Proposed Updated Final Safety Analysis Report Tables and Figures
(Mark-Ups; for Information Only)
(164 pages follow)

FINAL PLANT LAYOUT, PLAN C ABOVE
ELEVS. 620'-6", 623'-6" AND
624'-6", PLANT COMPLEX
FIGURE 1.2-5
(DWG. E-013-0005-00000)

Figure 2.4-9

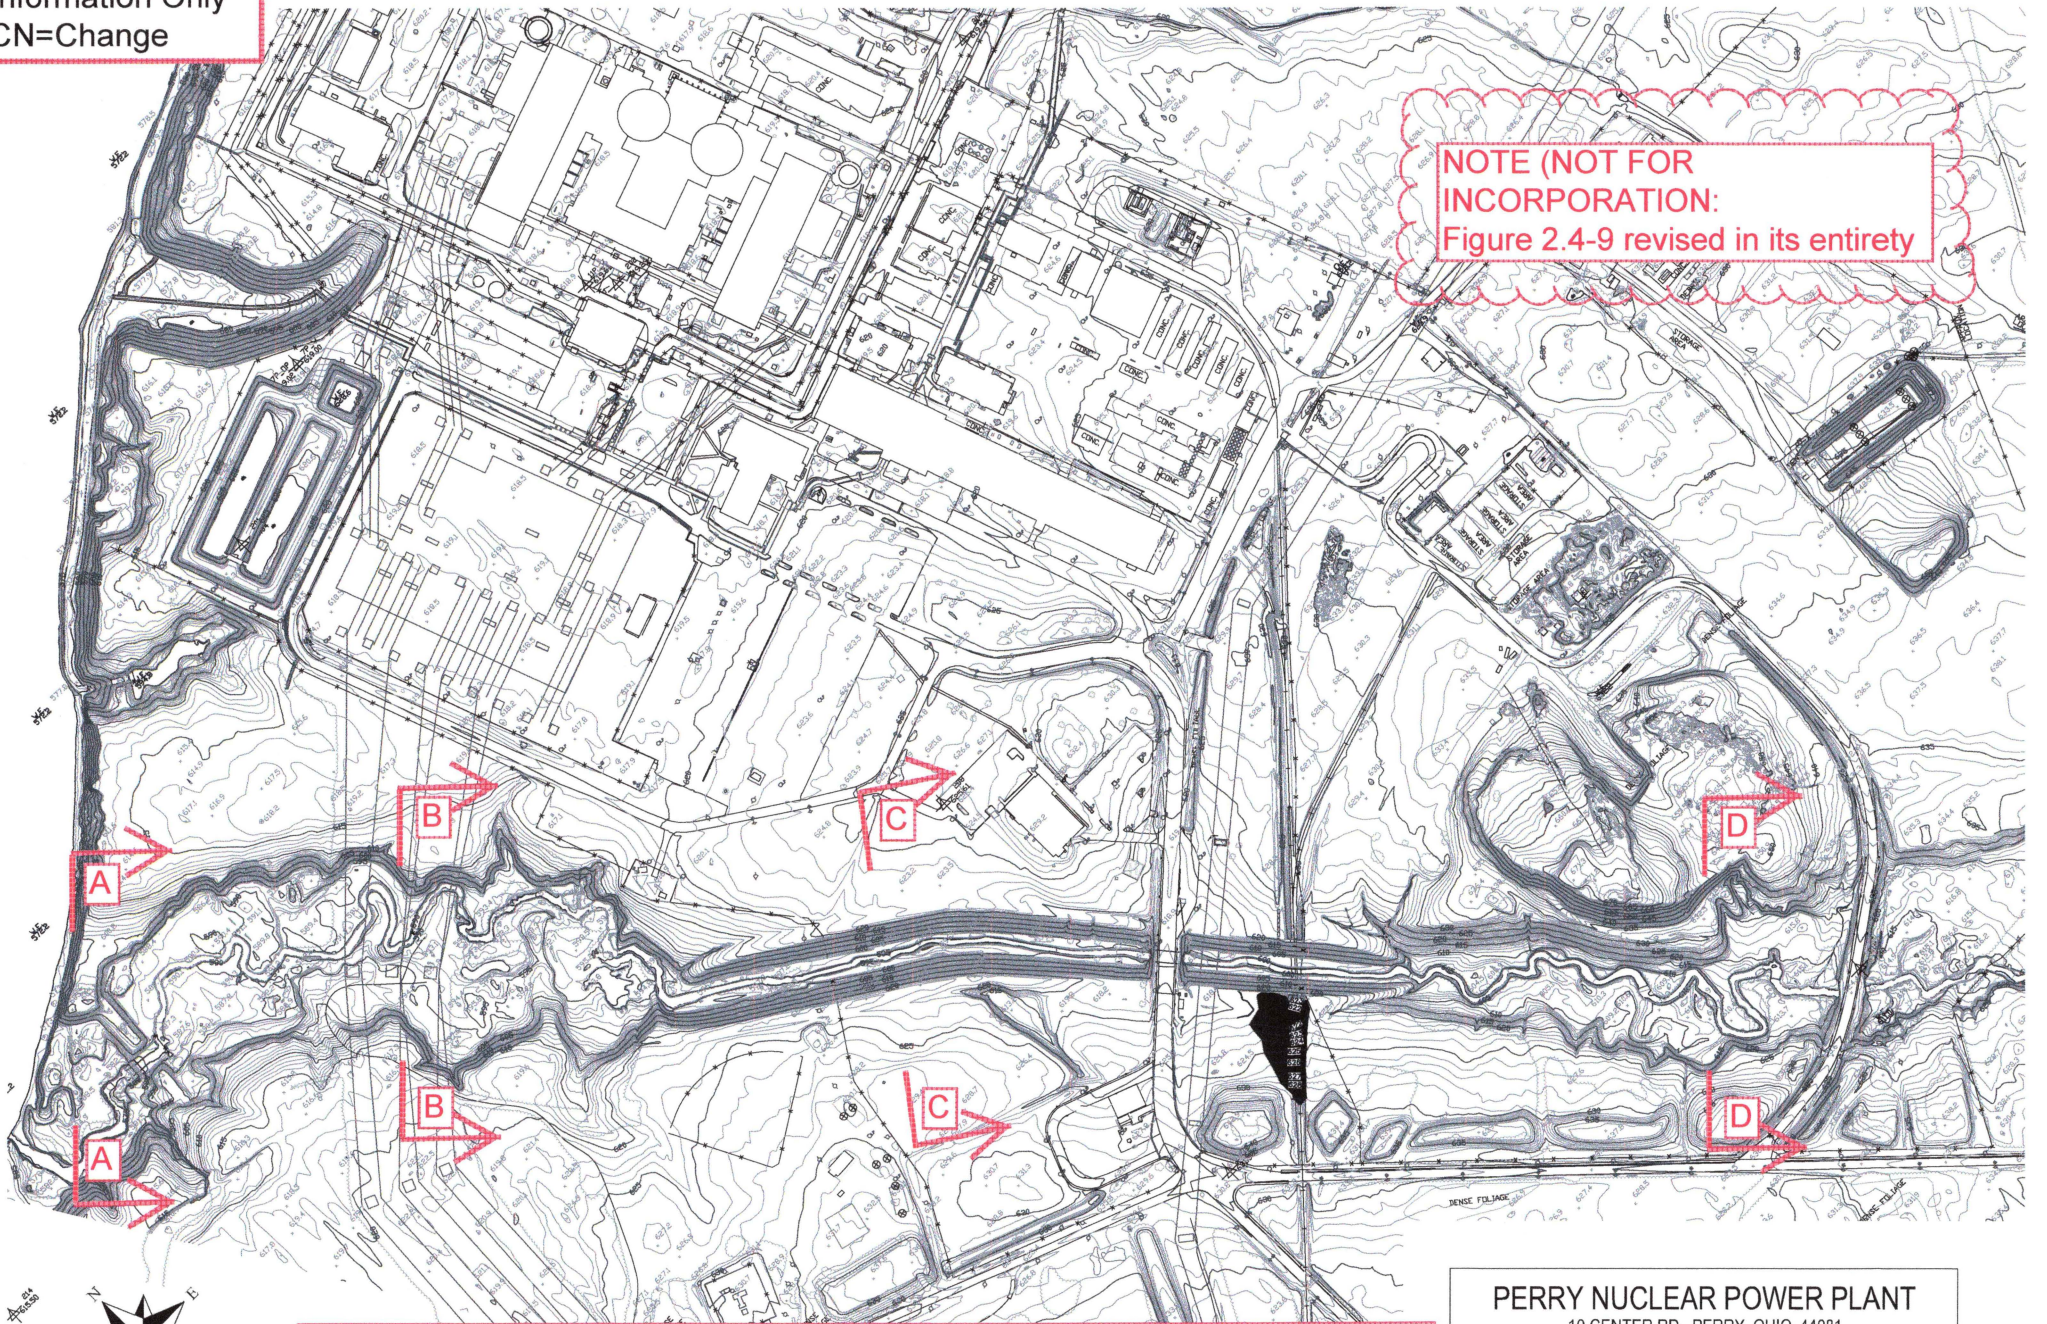
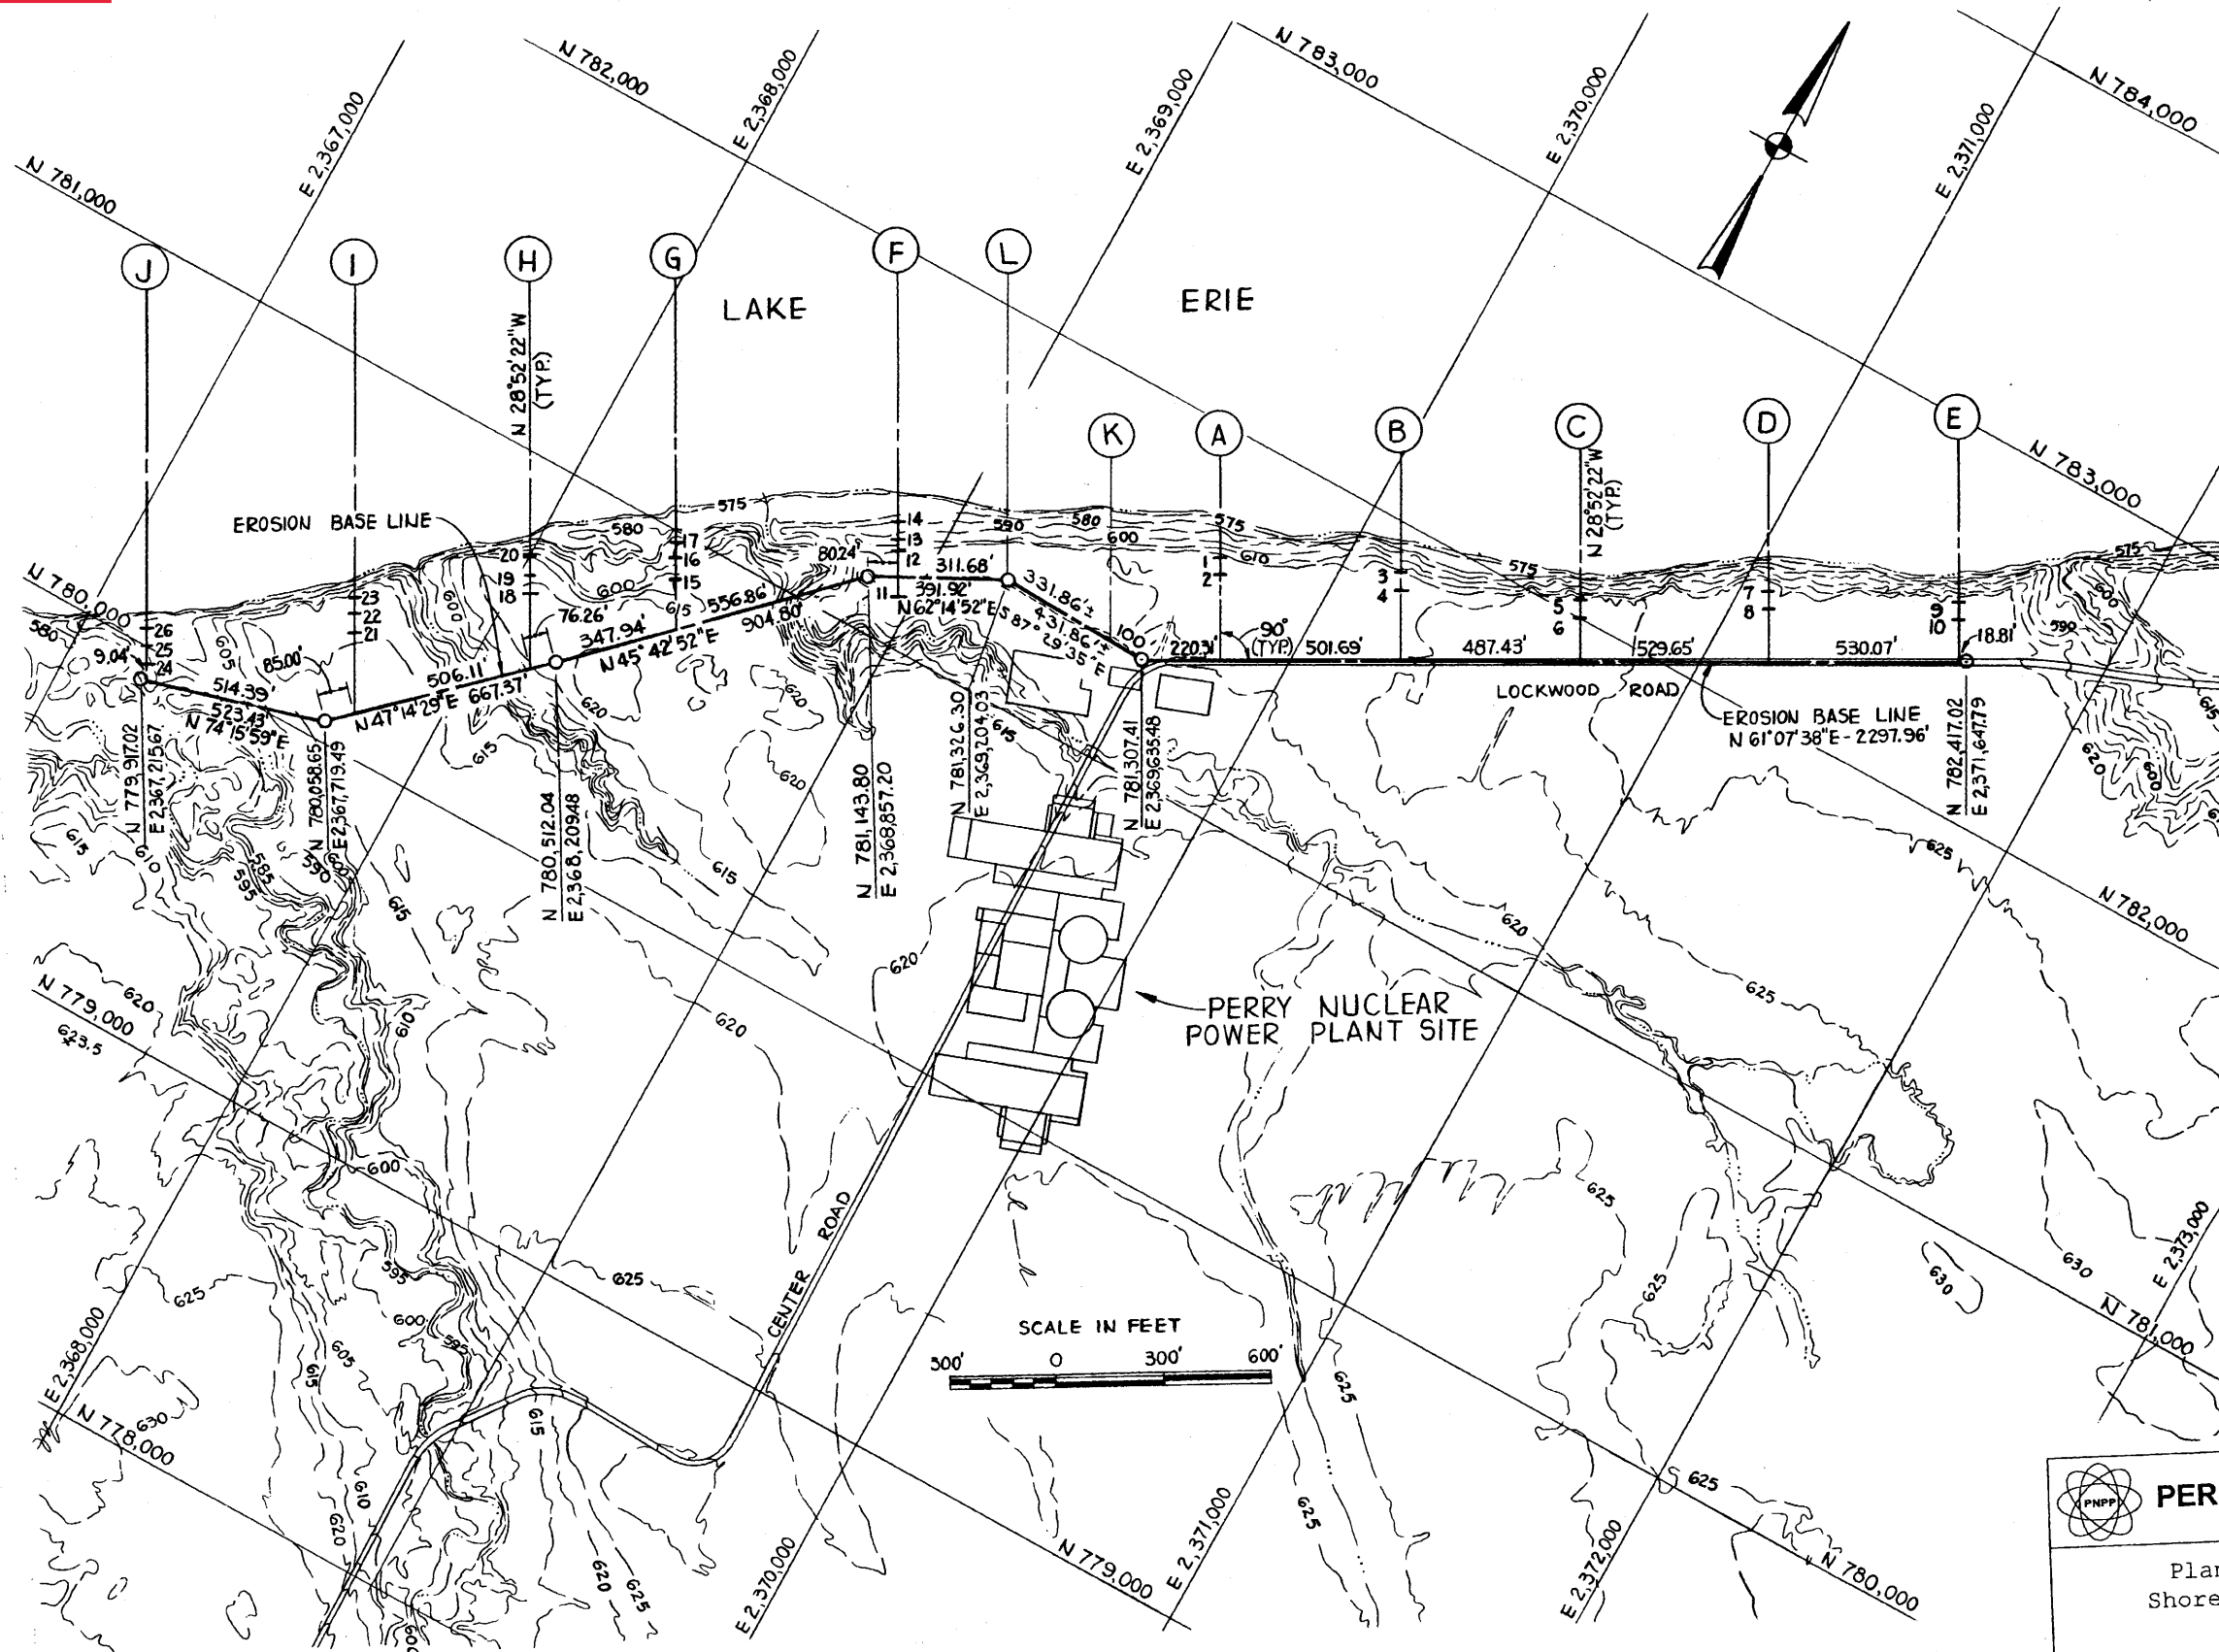
NOTE (NOT FOR
INCORPORATION:
Figure 2.4-9 revised in its entirety

- NOTES:
1. Elevations shown in this Figure are provided in North American Vertical Datum 1988 (NAVD88)
 2. For comparison to plant building elevations, convert NAVD88 to PLD
 3. NAVD88 + 0.93 ft = Perry Local Datum (PLD)
